Notice of Modification

Section 75W of the *Environmental Planning and Assessment Act 1979*

The project approval (06_0139) granted by the Minister for Planning for the Eastern Creek Waste Project on 22 November 2009.

11. Insert the following after Appendix 5:
- Appendix 6 – Site plans and drawings for the pre-sort enclosure and future stormwater plan

| Title | PROPOSED FUTURE STORMWATER MANAGEMENT PLAN |

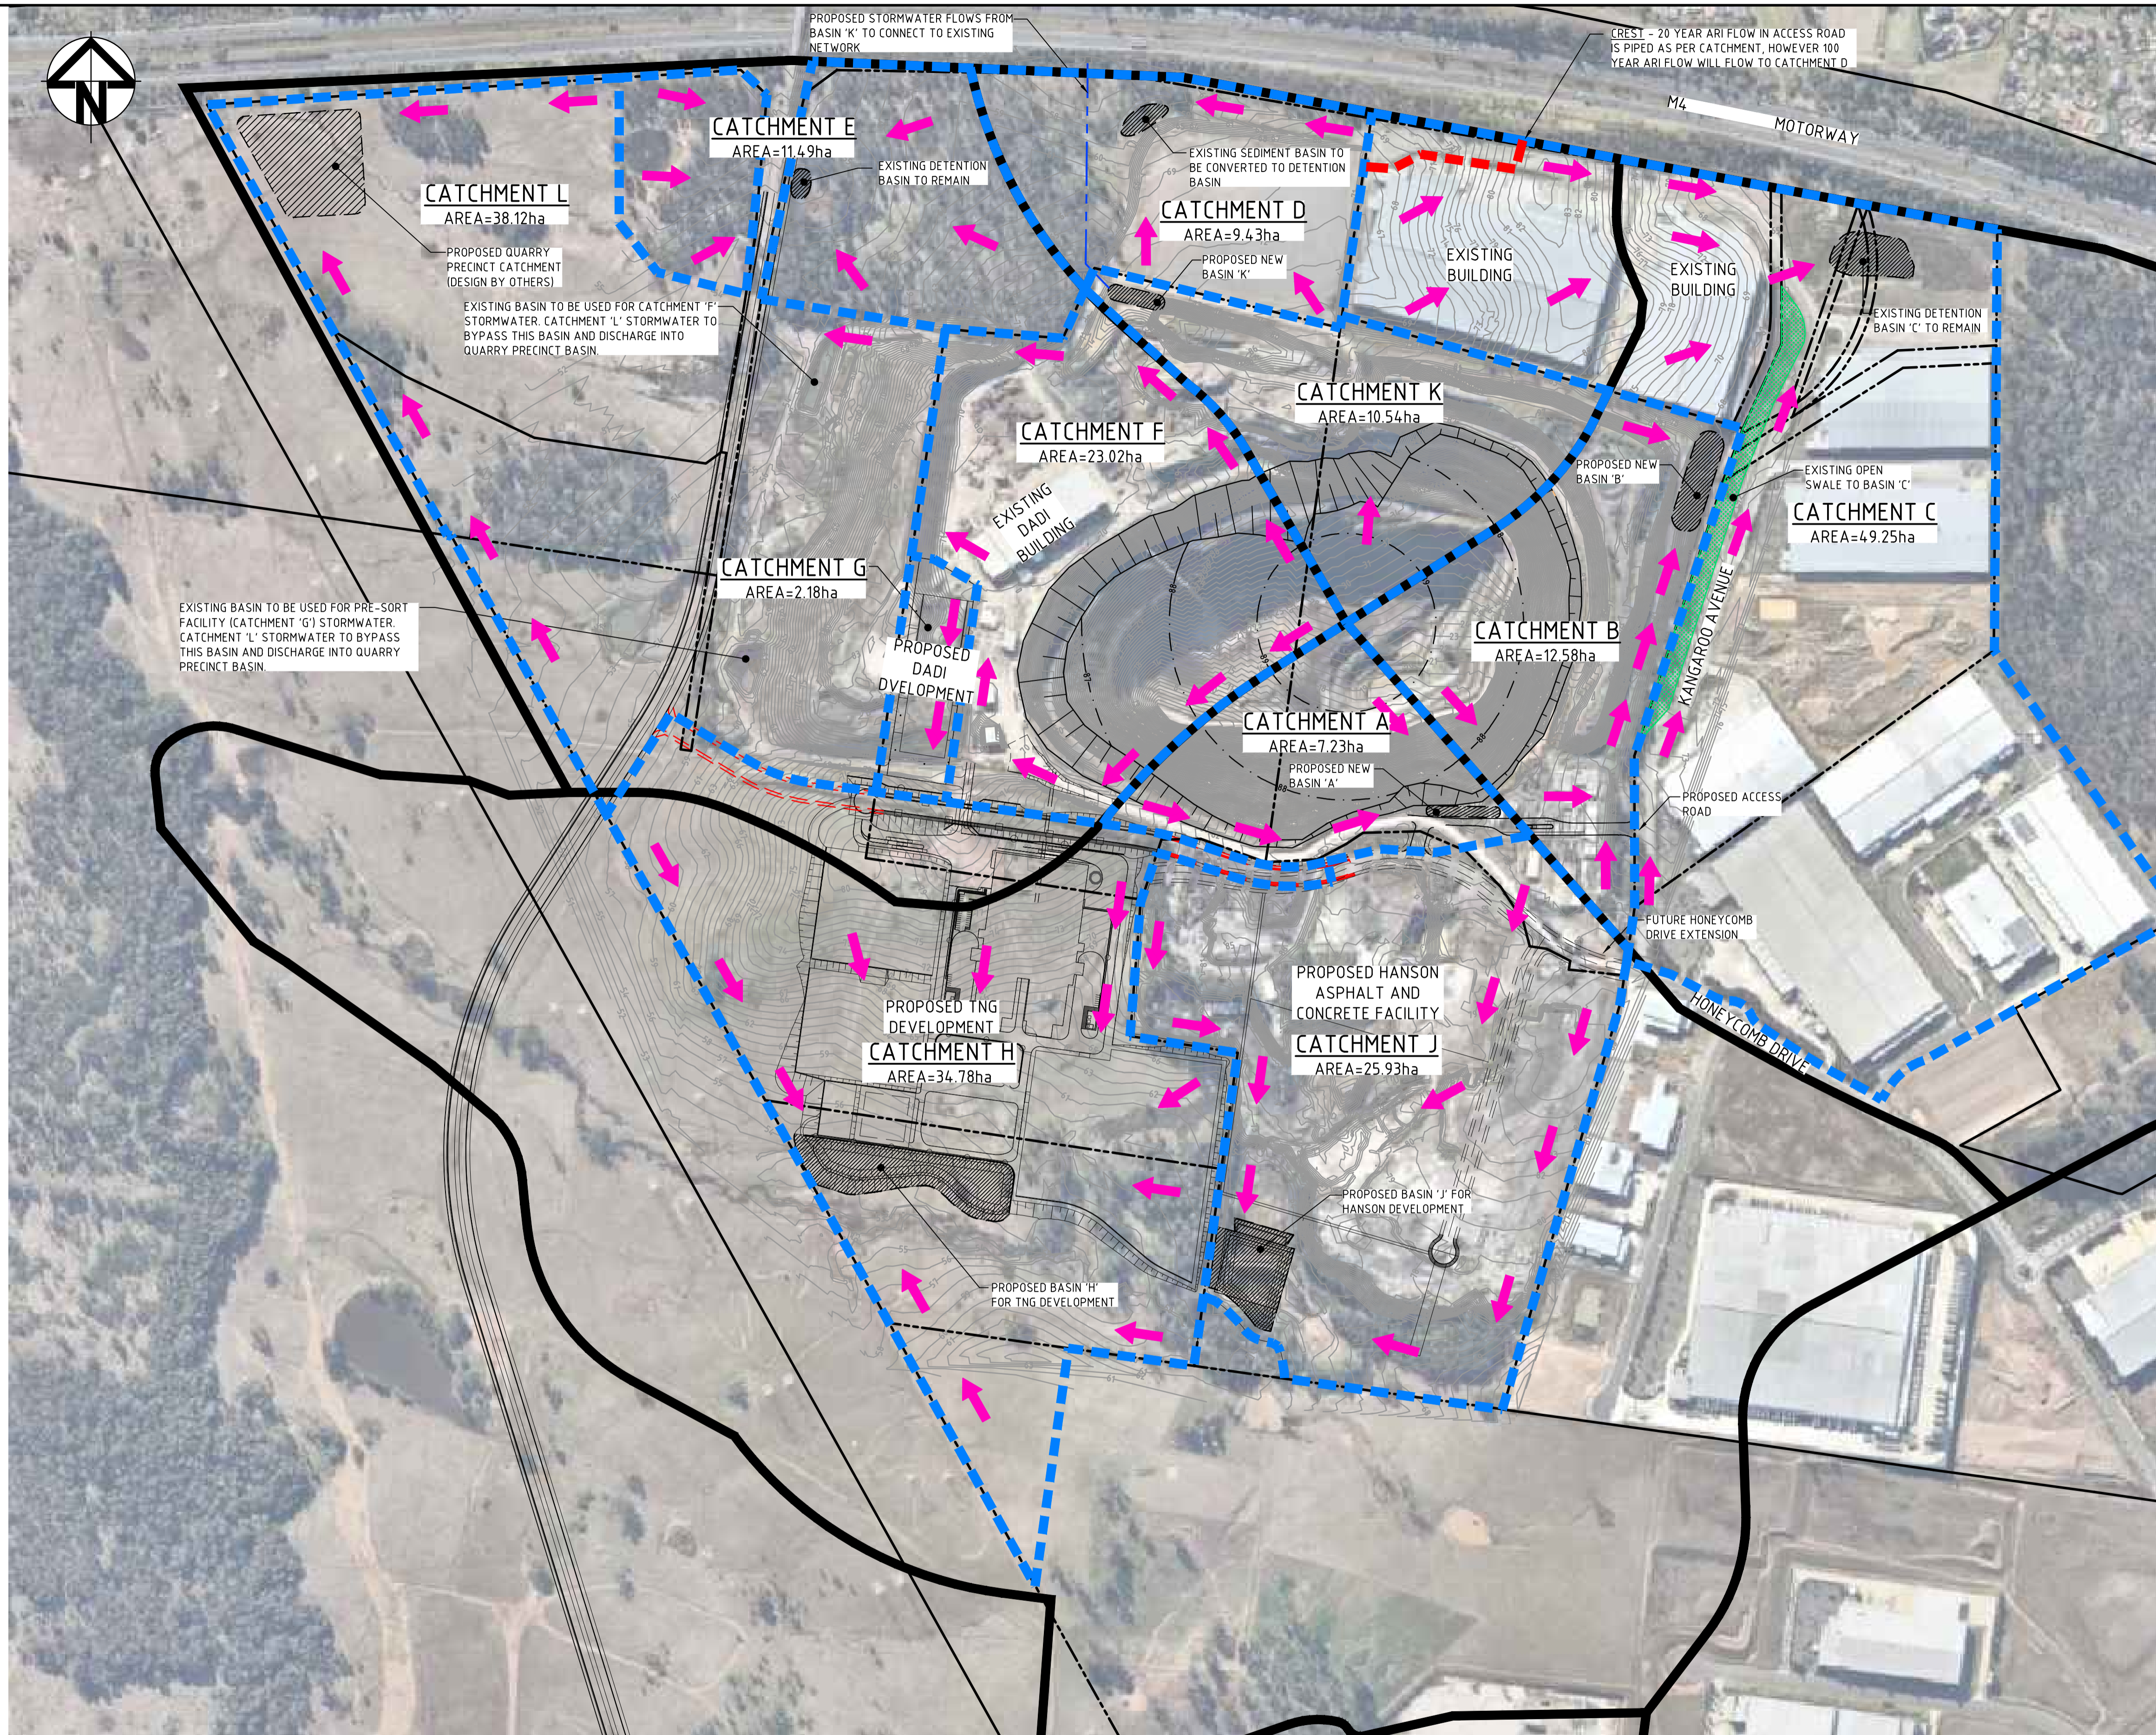
- a) be prepared in consultation with Council;
 - b) include details and specifications for the detention basins in Catchment G (as shown in Proposed Future Stormwater Management Plan, Drawing No. SKC077, Issue P6, dated 26 October 2015; and letter from Genesis Xero Waste to Blacktown City Council, dated 4 November 2015); and

4. Insert the following condition immediately after condition 25 of Schedule 3:
 - 25a. The Proponent shall prepare an Interim Stormwater Management Plan for the pre-sort enclosure, to the satisfaction of the Secretary. The plan must:
